Transgrid Reference Number: 2024-258

Development Application: DA24/0330

Location: 221-227 Luddenham Rd, Orchard Hills

Proposal: Warehouse and distribution centre

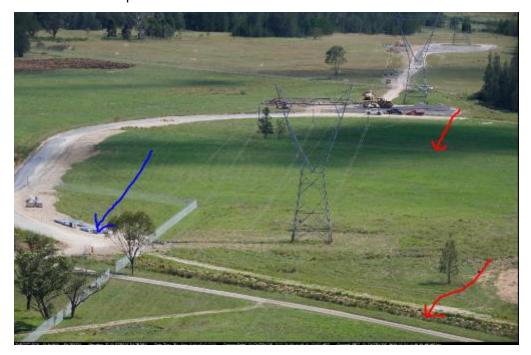
- Estimated to be situated around structure 525 on transmission line 39.
- Current access depicts Transgrid access to structures 525 and 524 from Patrons Ln and Luddenham
 Rd. will be impacted by the proposed development.
- The proposed Warehouse and distribution centre do not impact the tower exclusion zone.
- See the picture of where access will be impeded by the proposed development.
- 2023 aerial photography shows new access being installed to structures 513 & 524
- The developer may have provided track information under a different DA number.

- Red arrows water ways they will hinder access for Transgrid maintenance vehicles.
- Blue arrow development that will hinder access between structures.

- The development is to be designed so that during construction phase TransGrid is not restricted from undertaking normal maintenance & inspection activities and, at completion of works, access to Transmission Lines & structures shall be always available for Transgrid plant & personnel.
 - a) If any future fencing is to be proposed within the easement corridor, fencing is to be installed in accordance with TransGrid Fencing Guidelines.
 - b) If any fencing is to be proposed across the easement corridor or access track, a gate will be required to be installed to maintain continuous travel to the structure & along the easement.
- Consideration is to be given in the design works for any proposed access ways/roads to TransGrid's
 easement & structures to cater for the weight and size of TransGrid's maintenance vehicles to
 withstand the 43-tonne load capacity of maintenance trucks.
